CHAPTER 4

Revisions to the Draft EIR

Saddle Crest Homes ~~Screencheck~~ Draft EIR

TABLE 3.14-3 (REVISED)
SANTIAGO CANYON ROAD SEGMENT ANALYSIS RESULTS FOR EXISTING CONDITIONS
(HIGHWAY CAPACITY MANUAL METHODOLOGY)

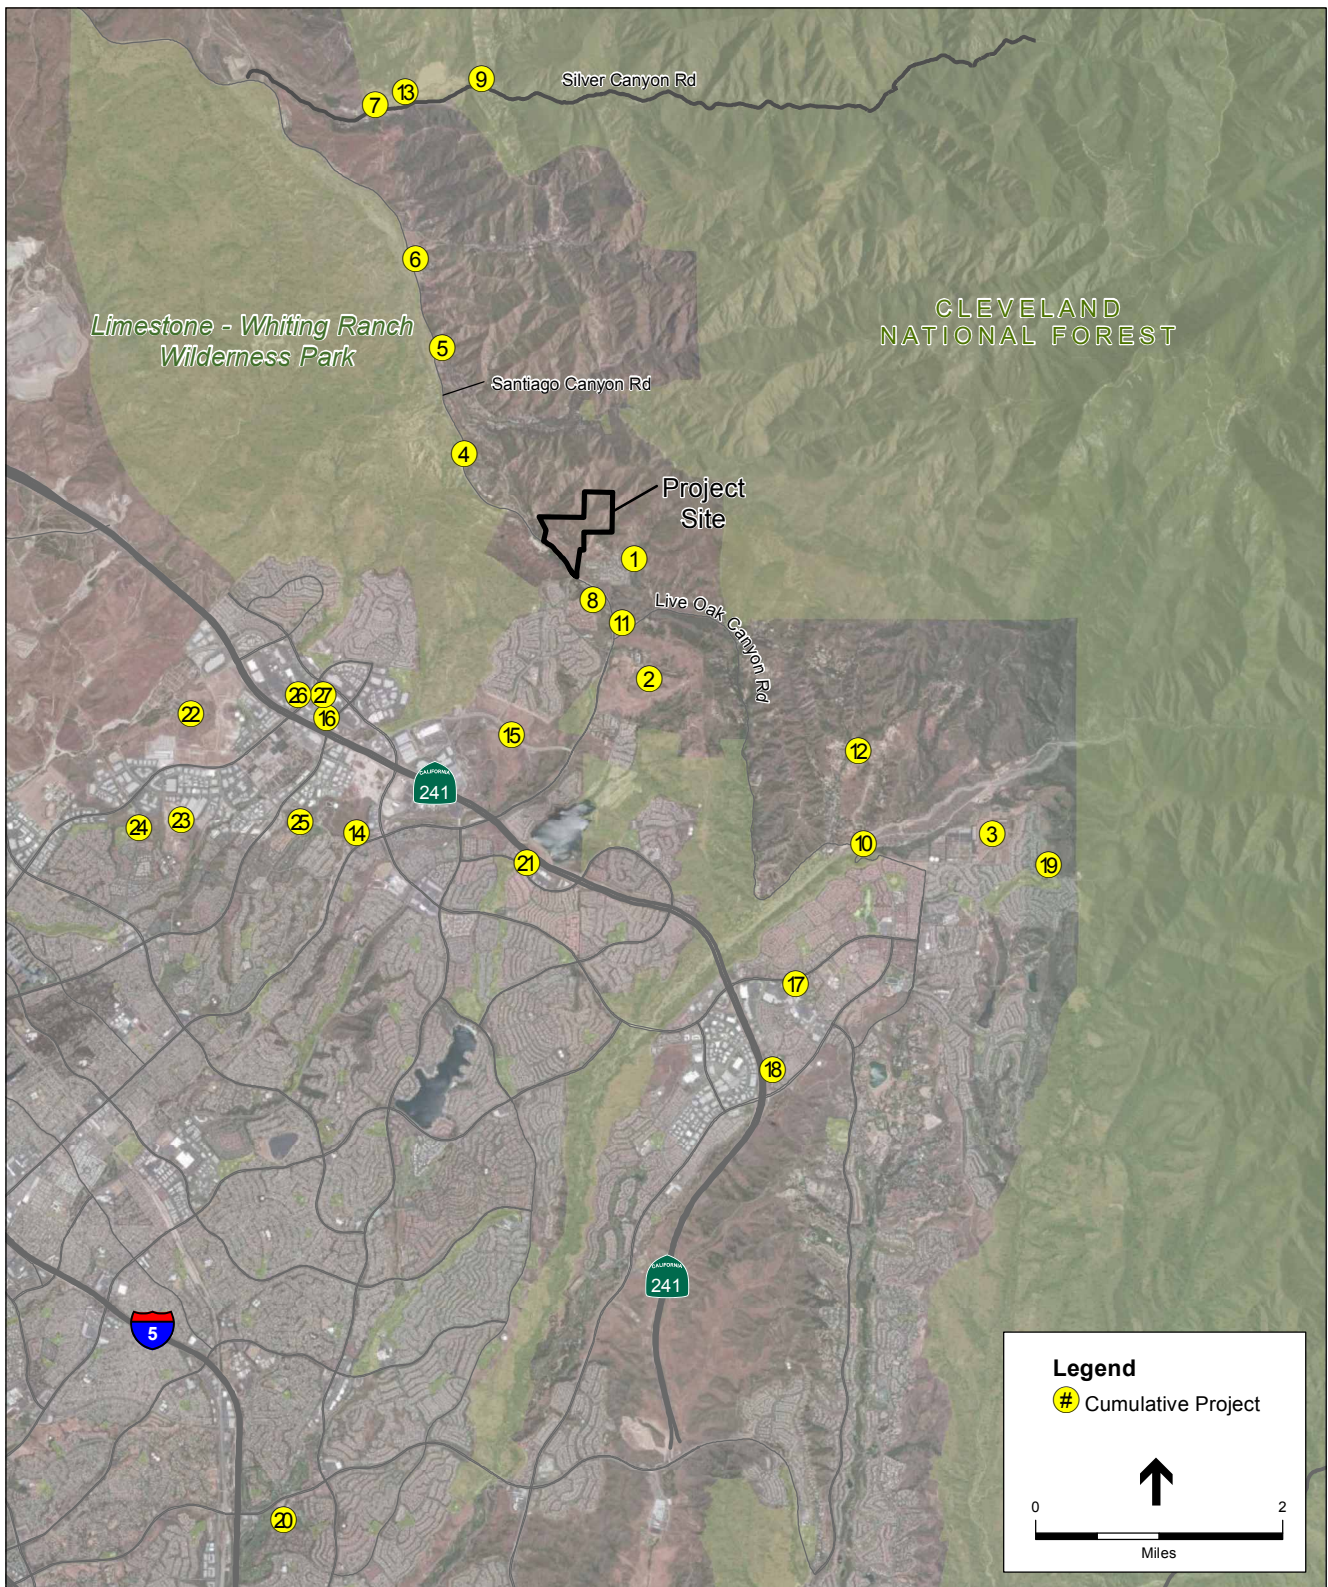
Page 3.14-16 of the Draft EIR, Section 3.14, *Transportation and Traffic*, is hereby modified as follows:

Road Segment	AM Peak Hour		PM Peak Hour	
	MPH / PTSF ^a	LOS	MPH / PTSF ^a	LOS
North of Modjeska Grade Road	<u>44.5</u> / 65.0%	C	<u>43.6</u> / 71.2%	D
South of Modjeska Grade Road	<u>43.9</u> / 67.6%	D	<u>44.1</u> / 69.1%	D
North of Live Oak Canyon Road	<u>44.1</u> / 67.0%	D	<u>44.3</u> / 68.1%	D

a **MPH = Average travel speed in Miles Per Hour** / PTSF = Percent Time Spent Following, which is based on the ability to pass slower vehicles on a two-lane roadway.

Revised Fuel Modification Cross Section (Appendix H)

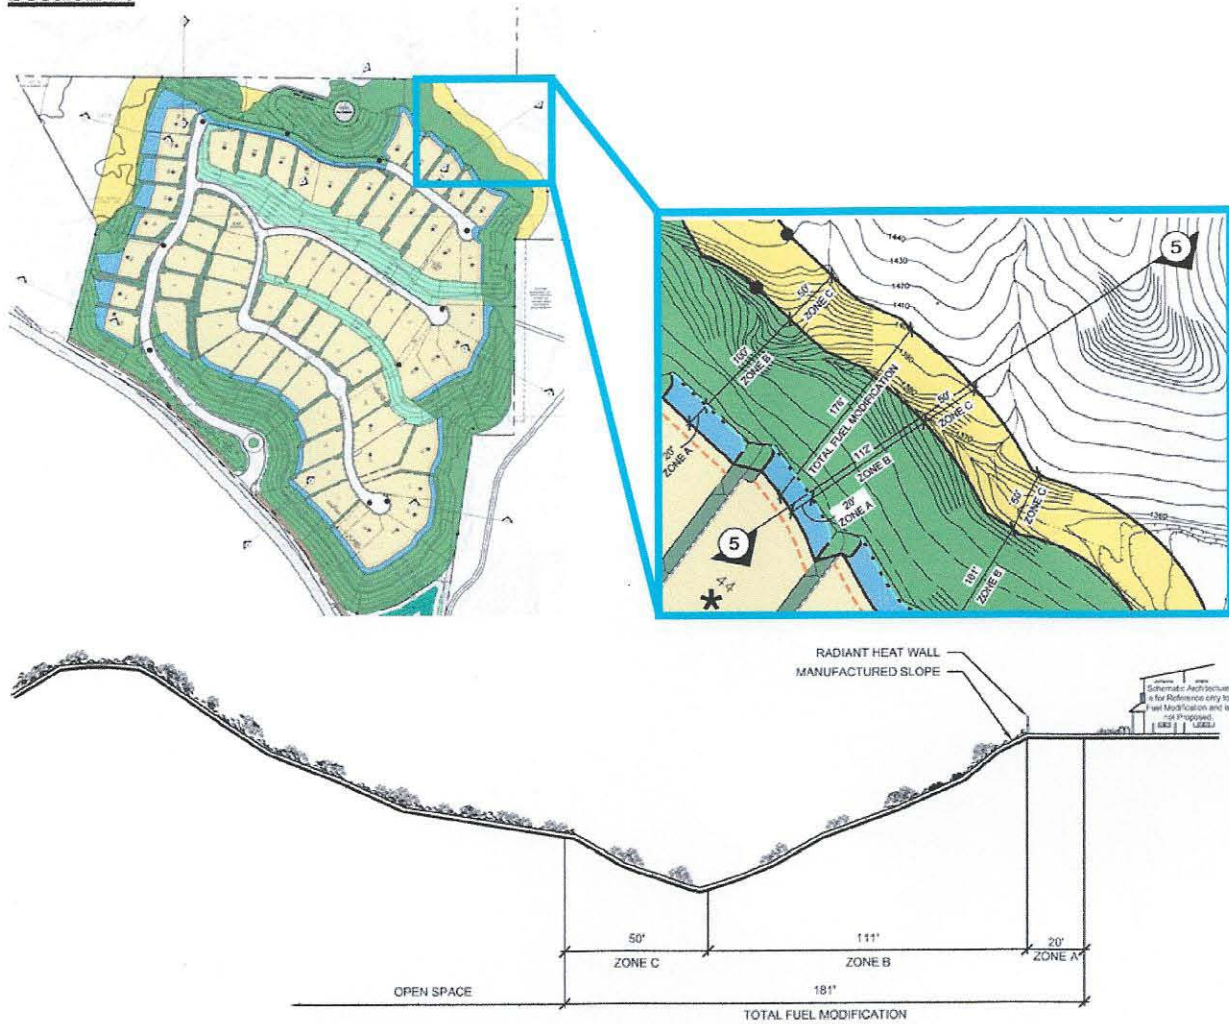
The fuel modification cross section (page 27 of Appendix H of the Draft EIR) has been modified and is included at the end of this chapter.
